February 12, 1992
LD-92-017

Subject: Response to NRC Requests for Additional Information

RESPONSE TO NRC REQUESTS FOR ADDITIONAL INFORMATION
PLANT SYSTEMS BRANCH

RAI 410.56

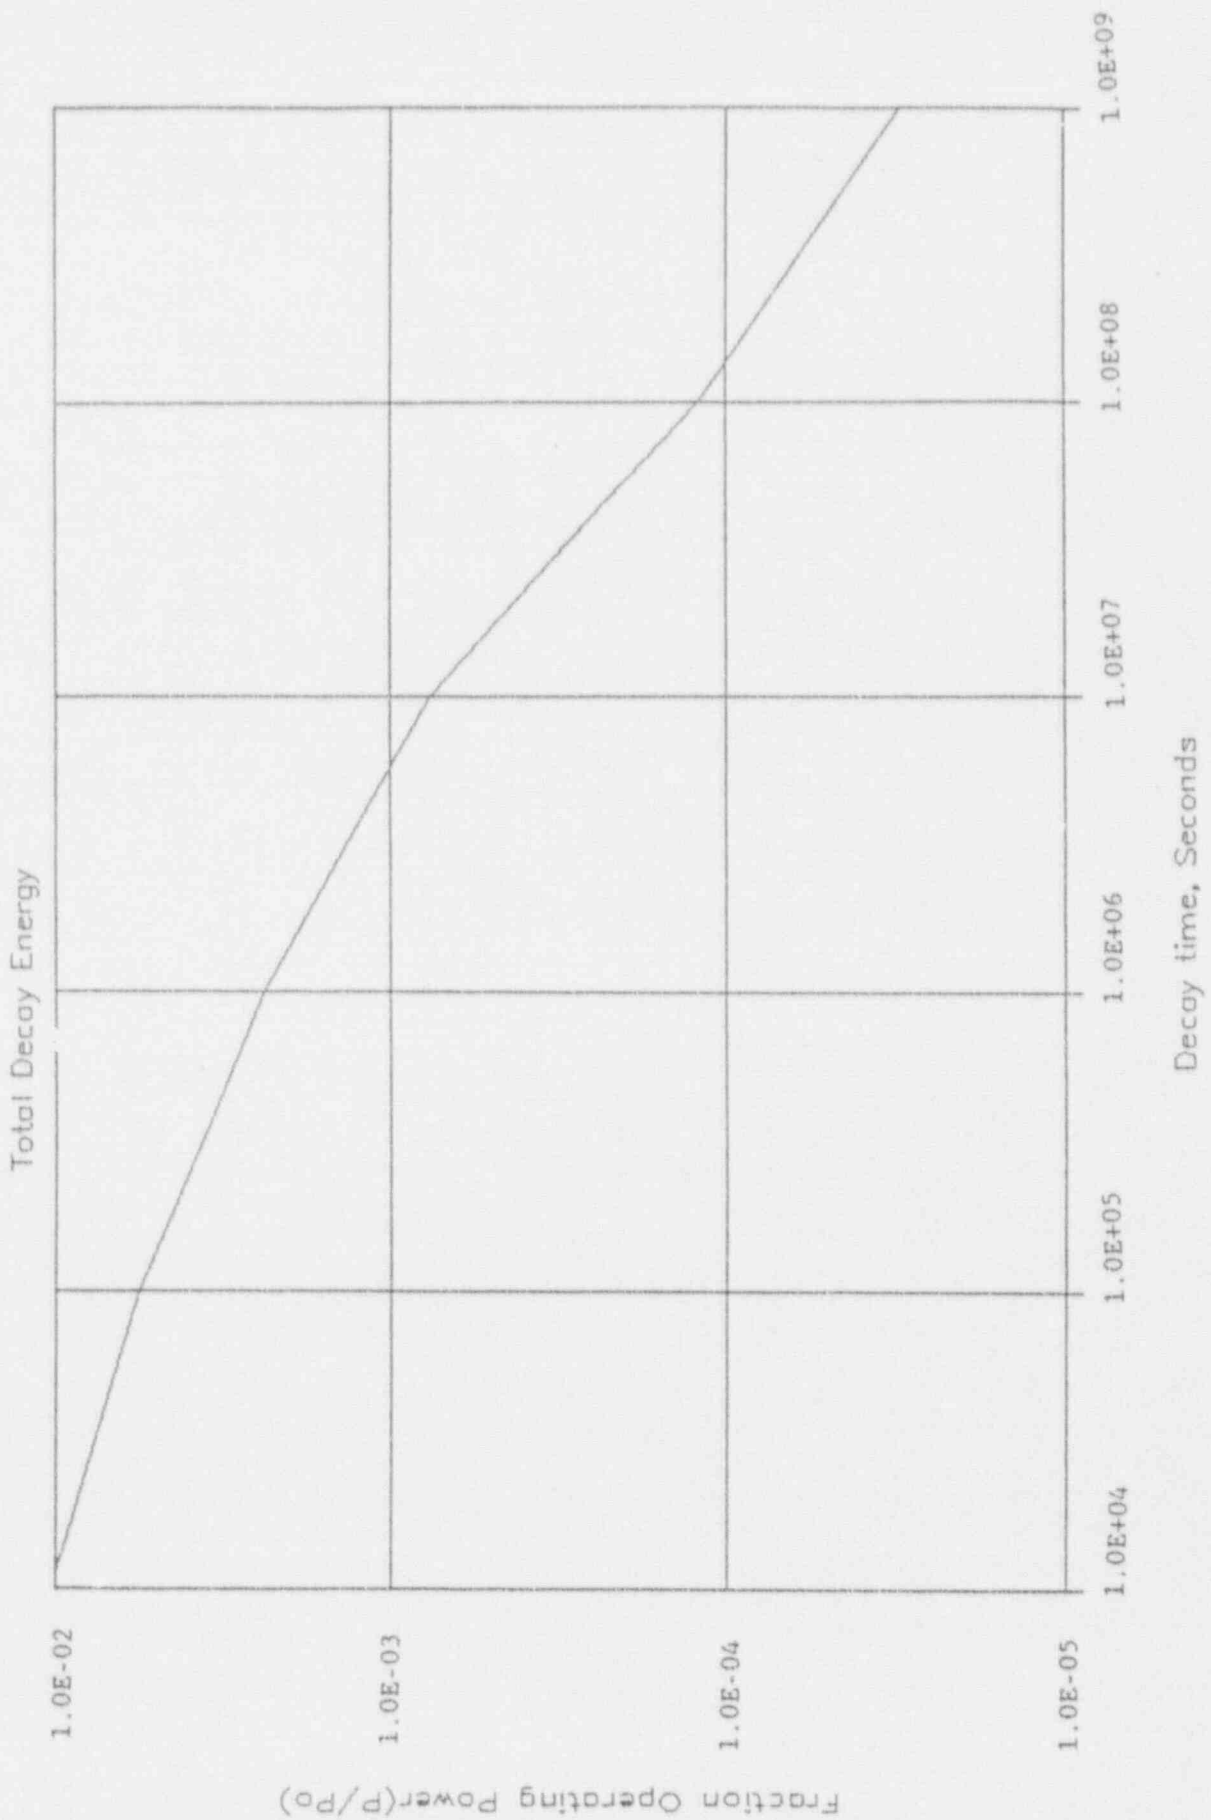
The response to RAI 410.56, regarding heat generation rate calculations is considered incomplete. Provide the residual decay heat release-vs-time curves generated with the ORIGEN 2 methodology to substantiate the statement of conservatism. Provide the resulting heat loads that need to be removed and a comparison of these heat loads to the design heat removal rates for the system.

The attached Figure shows the representative fuel decay energy versus time after shutdown calculated with the ORIGEN 2 methodology for a high average discharge burnup (44,000 Mwd/t). The results shown indicate uncertainties based on ANSI/ANS - 5.1, "American National Standard for Decay Heat Power in Light Water Reactors," 1979. In addition, an uncertainty of 10% is applied to the results in thermal-hydraulic analyses of the spent fuel pool, including calculation of the normal and maximum heat loads.

the normal heat load as described above. The resultant heat load for this case is 7.36×10^7 BTU/hr, which is the maximum heat load for the spent fuel pool. The heat load from any other combinations of spent fuel within the pool will result in heat loads lower than 7.36×10^7 BTU/hr. The design heat removal rate of the Pool Cooling and Purification System is 7.51×10^7 BTU/hr.
